BRRTS #:	02-50-562554	CLOSURE DATE:	08/15/2016
ACTIVITY NAME:	Additive Tank 338 Spill	FID #:	750011570
PROPERTY ADDRESS:	2267 County Highway HH	DATCP #:	
MUNICIPALITY:	Carson	PECFA#:	
PARCEL ID #:	01224070603

SUBJECT: Final Case Closure with Continuing Obligations  
Additive Tank 338 Spill, Junction City, WI  
DNR BRRTS Activity #: 02-50-562554  
FID #: 750011570

### **ADDITIONAL AREAS MAINTENANCE PLAN**

FIGURE 2  
CAPPED AREA LOCATIONS  
JUNCTION CITY TERMINAL  
FLINT HILLS RESOURCES, LP  
JUNCTION CITY WI

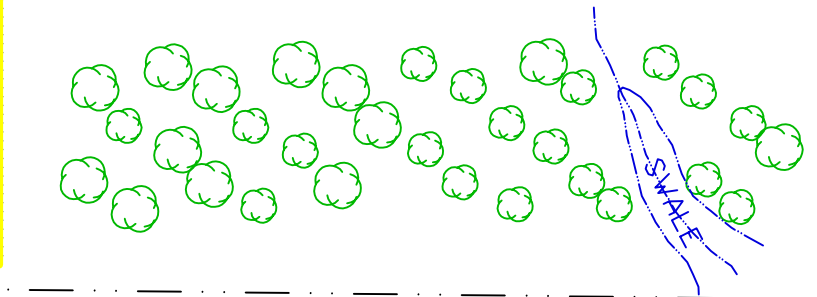
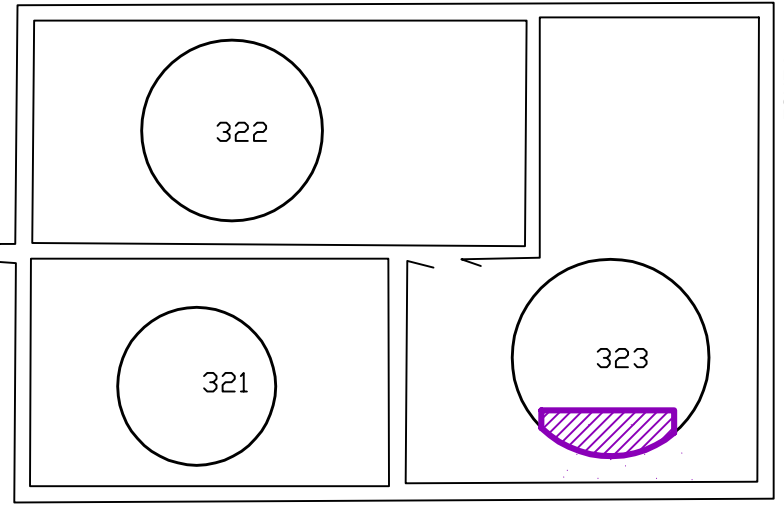
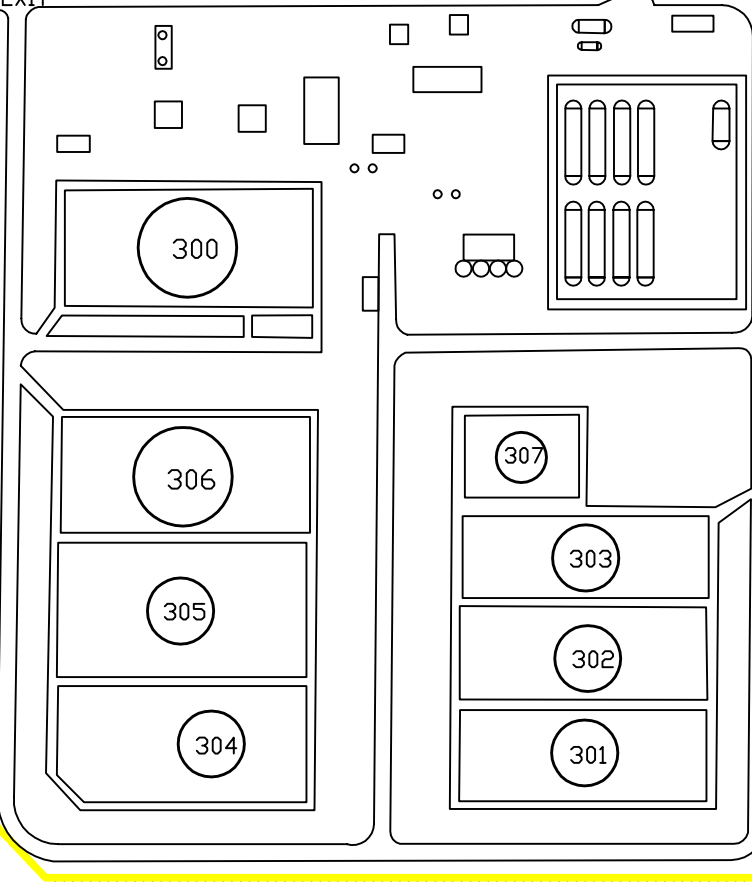
The soil cover that exists in the location shown on the attached map, Capped Area Locations, Figure 2, July 22, 2016 and Soil Contamination, Figure B.2.a, shall be maintained in compliance with the attached maintenance plan in order to prevent direct contact with residual soil contamination that might otherwise pose a threat to human health.

As a condition of site closure, the caps covering the Additional Areas (as indicated on Figure 2, attached), must be maintained to minimize direct contact with residual impacted soil and minimize potential impacts to groundwater. Caps consist of structures (Tank 323 & the fuel loading rack), asphalt (the fuel loading rack & the additive tank area), and soil (additive tank 338 area). The additive tank 338 cap area is located on level ground and consists of a minimum of 2-feet of soil, revegetated with grass, therefore it meets the cover design goals in the WDNR Guidance for Cover Systems as Soil Performance Standard Remedies (RR-709).
